**Response to**  
**Request for Additional Information No. 230, Supplement 1**

**U. S. EPR Standard Design Certification**  
**AREVA NP Inc.**  
**Docket No. 52-020**

**SRP Section: 14.03.02 - Structural and Systems Engineering - Inspections, Tests,  
Analyses, and Acceptance Criteria**  
**Application Section: 14.3.2**

Figure 2.1.1-1—U.S. EPR Building Layout Showing NI Structures Location

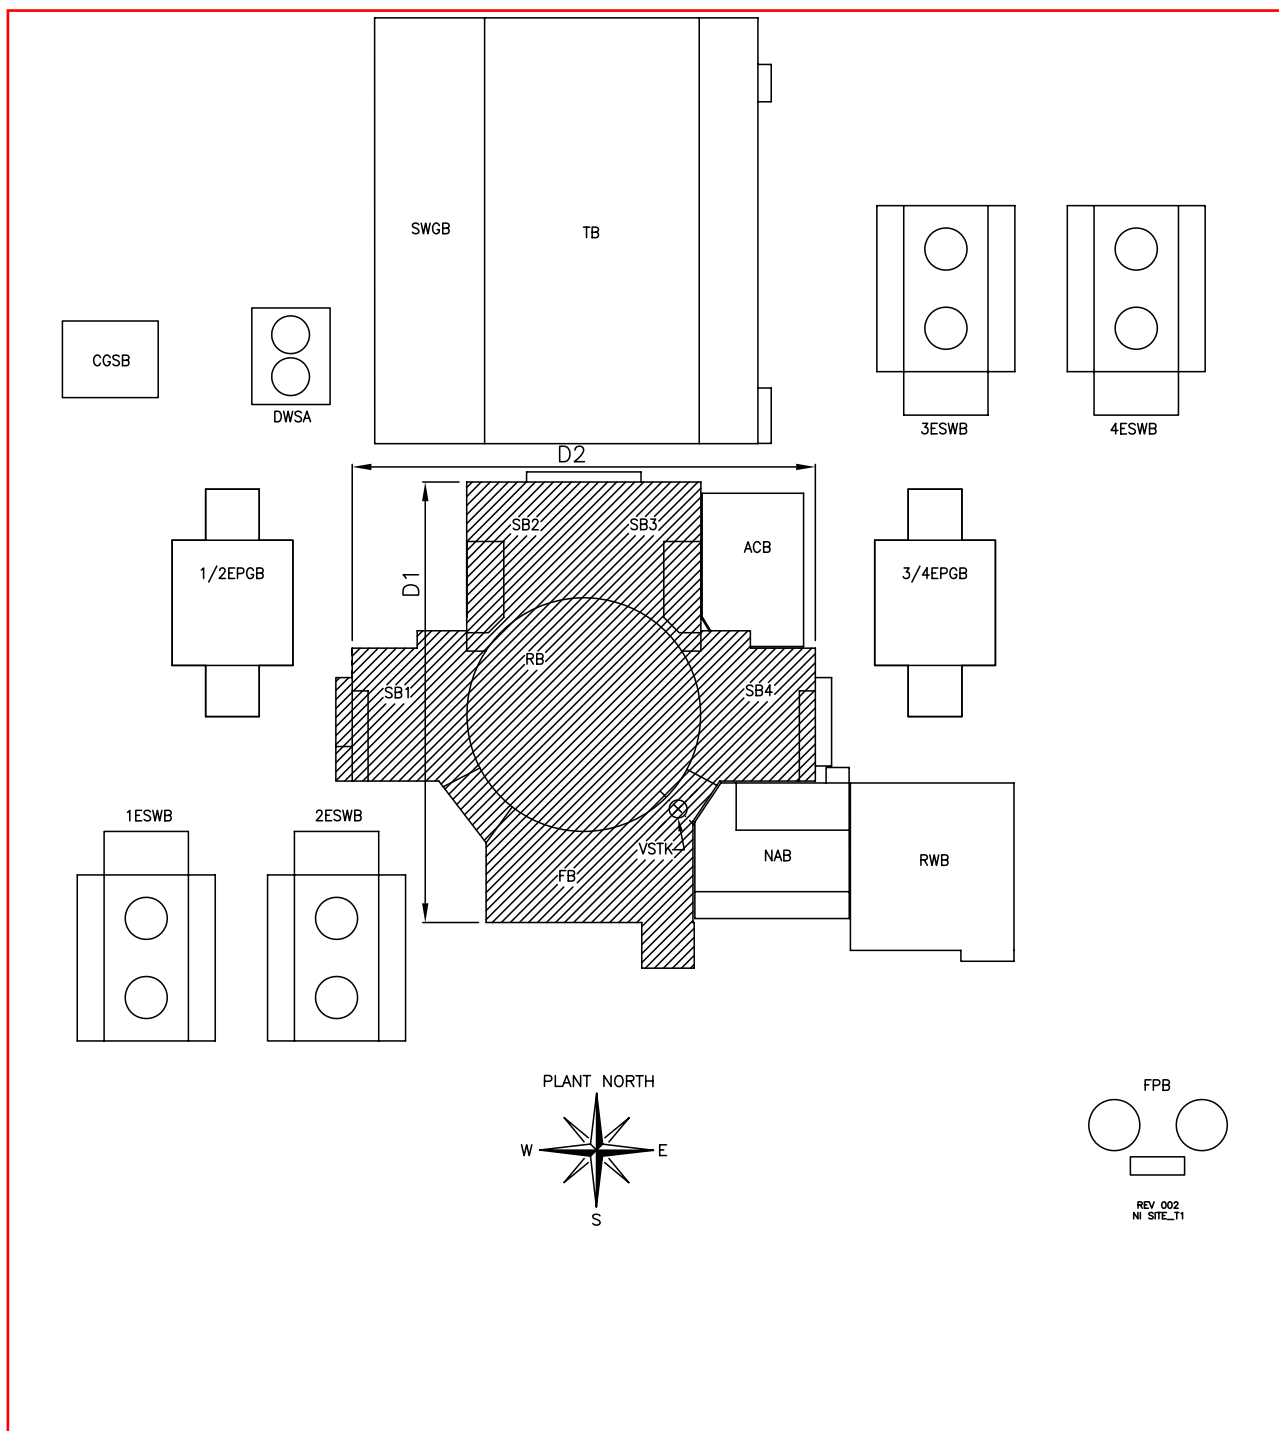
Tier 1, Section 2.1 does not identify floor elevations. It is difficult to determine where a particular plan view belongs in each structure. The staff requests that floor elevations be added to the elevation views. Also in Figure 2.1.1-1 the designation for dimension D1 is missing in the figure and should be corrected.

Reference floor elevations will be added to U.S. EPR FSAR Tier 1, Figure 2.1.1-9, Figure 2.1.1-12, Figure 2.1.1-14, Figure 2.1.1-17, Figure 2.1.1-19, Figure 2.1.2-3, Figure 2.1.5-4, and Figure 2.1.5-5 with section views that are cross-referenced by plan views. These floor elevations are for reference purposes and are not considered part of U.S. EPR FSAR Tier 1 ITAAC.

The D1 dimension label in U.S. EPR FSAR Tier 1, Figure 2.1.1-1 will be moved so that it is clearly visible.

U.S. EPR FSAR Tier 1, Figure 2.1.1-1, Figure 2.1.1-9, Figure 2.1.1-12, Figure 2.1.1-14, Figure 2.1.1-17, Figure 2.1.1-19, Figure 2.1.2-3, Figure 2.1.5-4, and Figure 2.1.5-5 will be revised as described in the response and indicated on the enclosed markup.
